## M091.0 Extended Change Cup Kit for BevMax 2 and BevMax 3 Venders

7/31/07

**Reason:** To provide instructions for installing an Extended Change Cup assembly in BevMax 3 and BevMax 2 Venders that were produced prior factory installation.

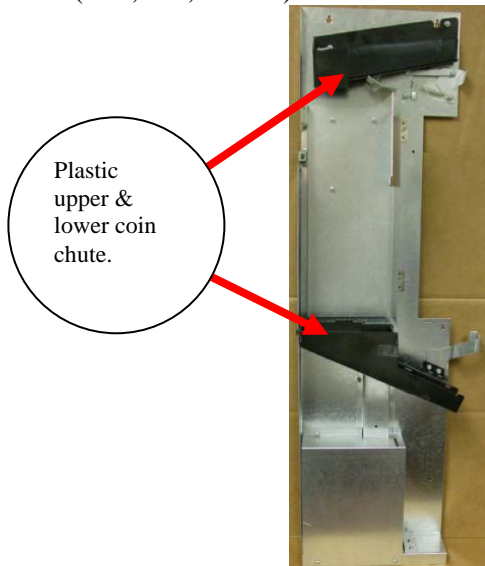
3. Remove existing Lower Coin Chute.
  - a. On Venders produced between 8542-0081AF to 8776-0044CG (6/11/08) remove the existing black plastic Lower Coin Chute.

- b. On Venders prior to 8542-0081AF remove the existing Coin Mech Housing Assembly.

Plastic upper & lower coin chute.

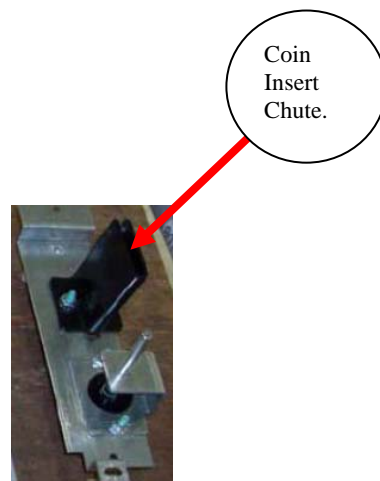
4. Install new Lower Coin Chute.

- a. On Venders produced between 8542-0081AF to 8776-0044CG (6/11/08) install the new black plastic Lower Coin Chute (801,823,42x.x1).

Note lower half of chute cover has been removed.

- b. On Venders prior to 8542-0081AF install the new Coin Mech Housing Assembly (647,001,00x.x3).
